Redlined Site Plan

THE VILLAGE AT ACACIA

Redlined Landscape Plan

LANDSCAPE SITE PLAN

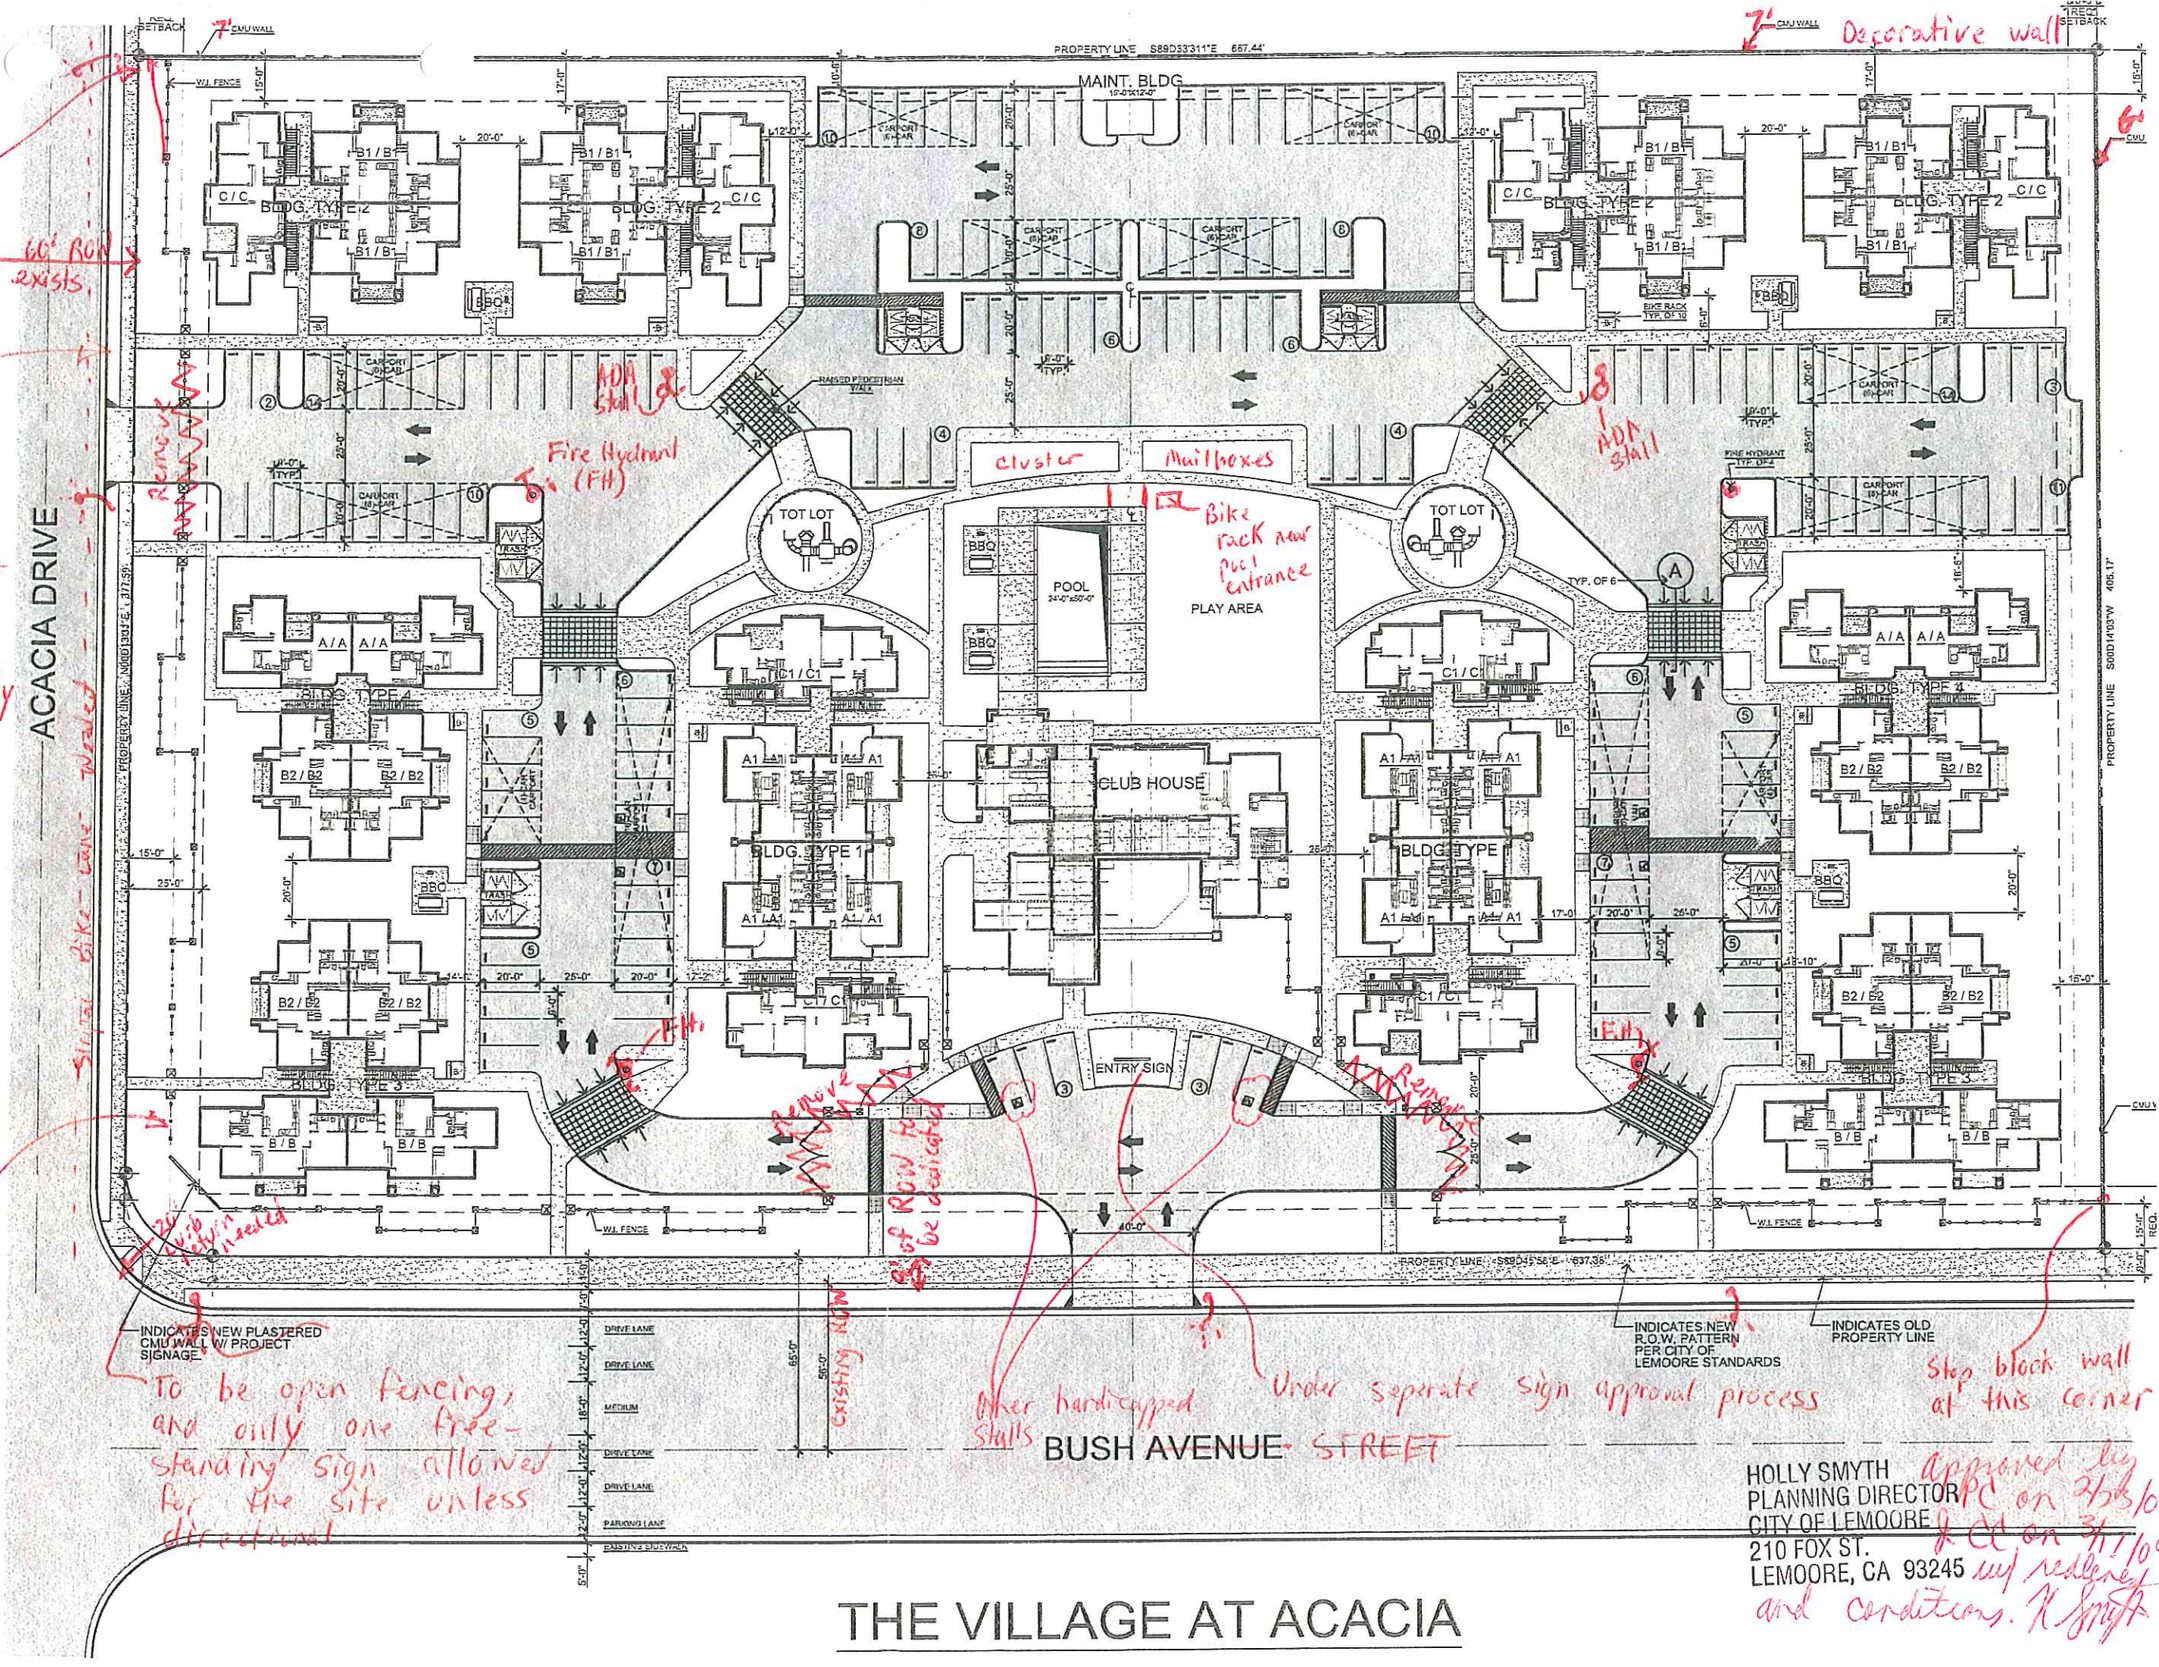
- Fencing corner to be 3' in back of sidewalk here

60' ROW exists.

- 10' PUE to be dedicated behind ROW along Acacia Dr. and Bush St.

- Enclosed fire department connections to be incorporated into bldg. design on the northerly sides of buildings close to parking lots.

- Wrought iron fence to be 3½' per City Zoning Ordinance
